This amendment modifies the Technical Specifications relating to the replacement of 136 of 368 fuel assemblies in the reactor core of VYNPS constituting refueling of the core for cycle 4 operation.

VERMONT YANKEE NUCLEAR POWER CORPORATION

VERMONT YANKEE NUCLEAR POWER STATION

Amendment No. 25
License No. DPR-28

Figure 3.11-1C
 Vermont Yankee Bypass Flow Holes Plugged, 8 x 8, 8D274 Fuel

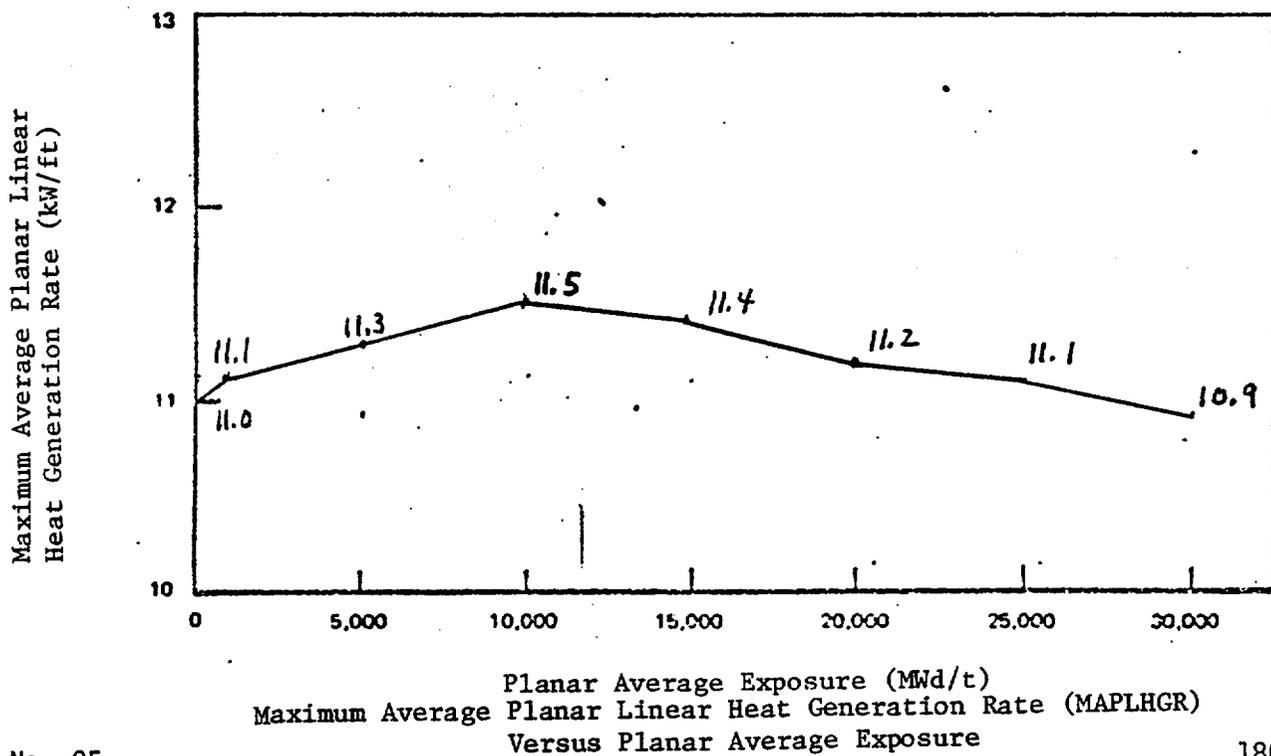
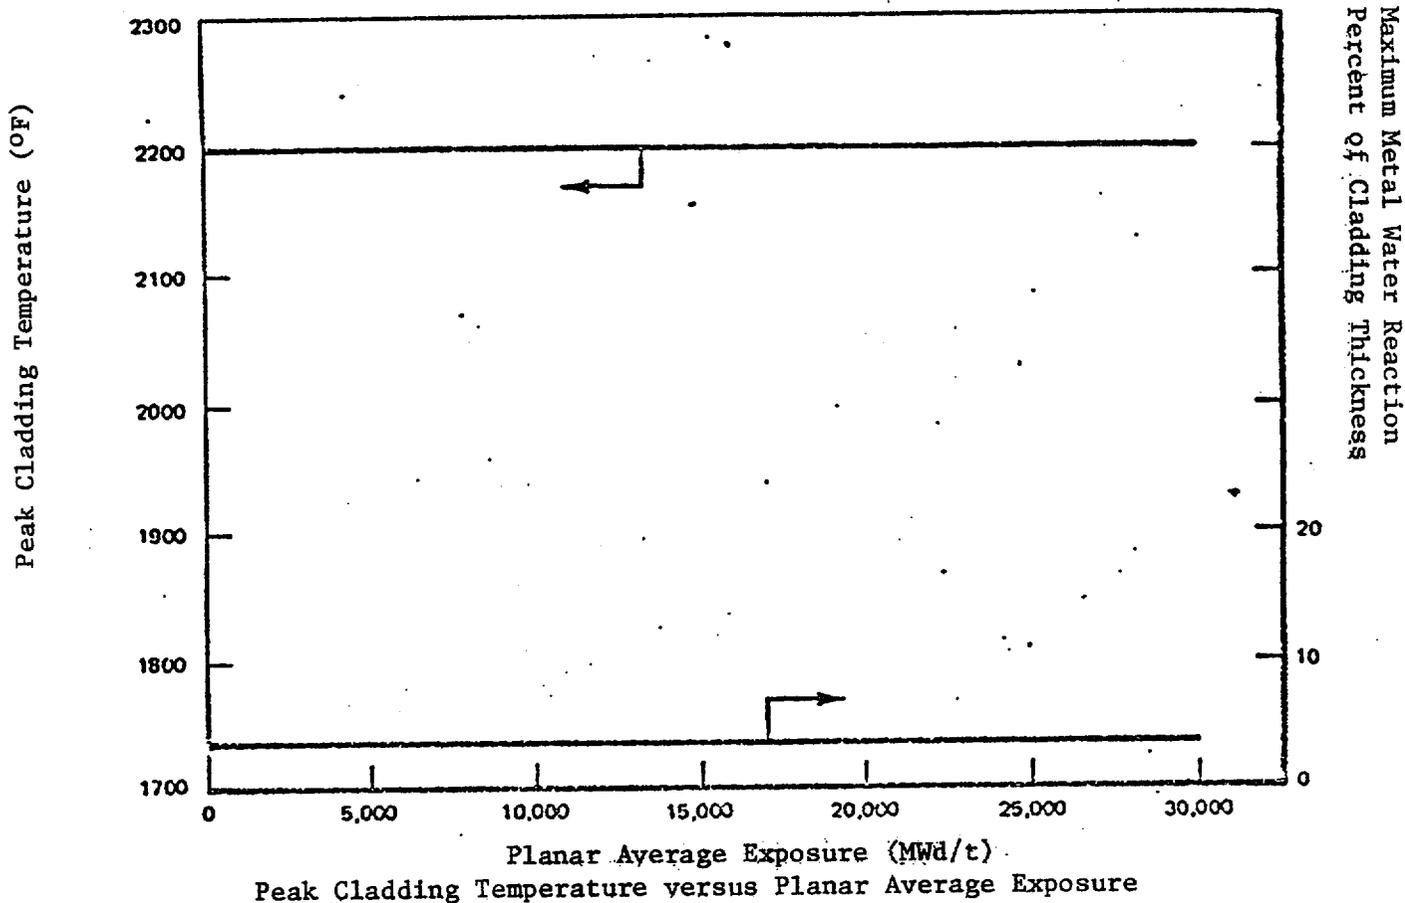
During steady state power operation, the APLHGR for each type of fuel as a function of average planar exposure shall not exceed the limiting values shown in Figures 3.11-1A through E. If at any time during steady state operation it is determined by normal surveillance that the limiting value for APLHGR is being exceeded action shall be initiated within 15 minutes to restore operation to within the prescribed limits. If the APLHGR is not returned to within prescribed limits within two (2) hours, the reactor shall be brought to the cold shutdown conditions within 36 hours. Surveillance and corresponding action shall continue until reactor operation is within the prescribed limits.

The response of the lead test assemblies and the high gadolinia assemblies to a Loss-of-Coolant accident was analyzed by the licensee using the same assumptions as for the 8D274 reload fuel. The MAPLHGR curve is given in Table A6.1 of reference (1). Since the LTA's are of similar nuclear design to the standard assemblies, we conclude that the previous LOCA analysis is applicable and is therefore acceptable.

Figure 3.11-1D
 Vermont Yankee Bypass Flow Holes Plugged, 8 x 8, LTA

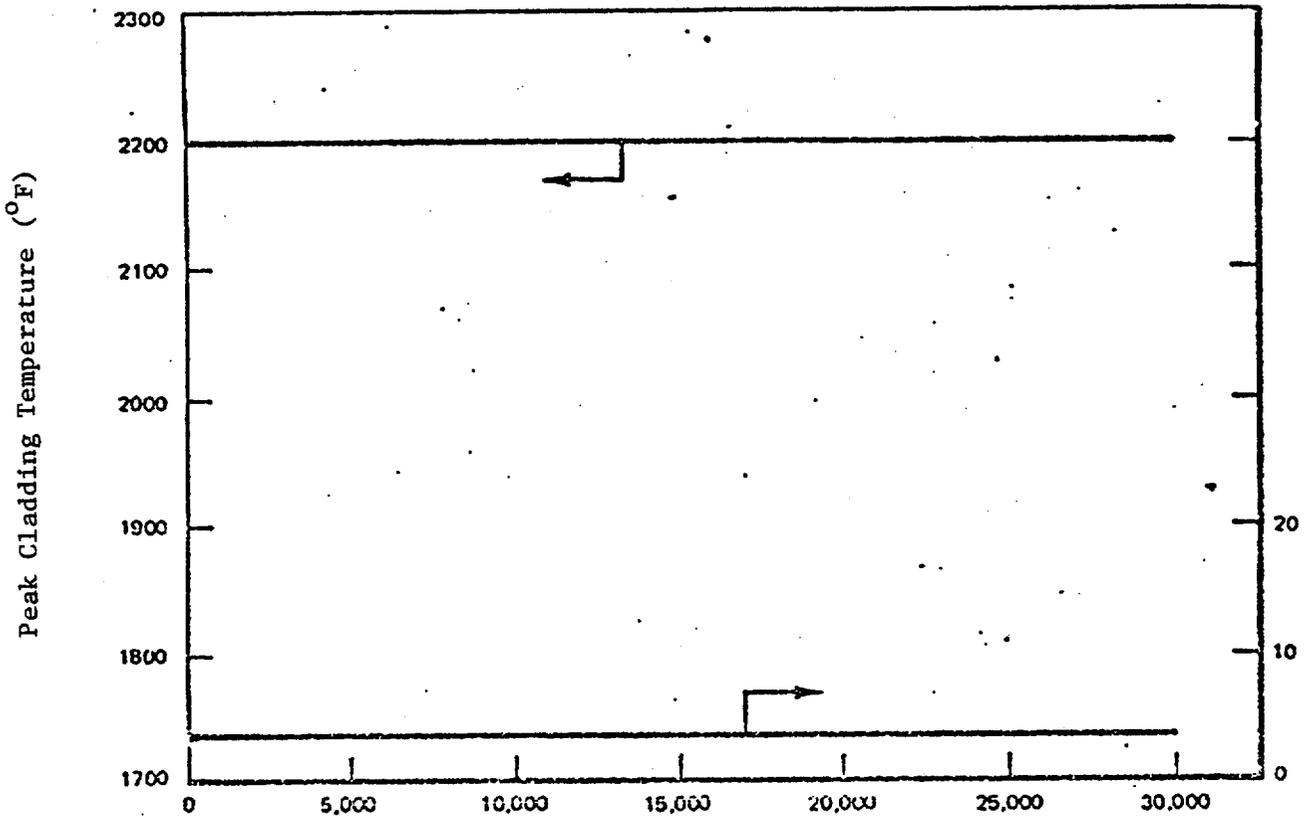
The use of natural uranium in the extremities of the LTA is intended to provide a more efficient use of the total amount of uranium in the core. The nuclear characteristics of the LTA's are not significantly different from the standard 8 x 8 8D274L fuel assemblies.
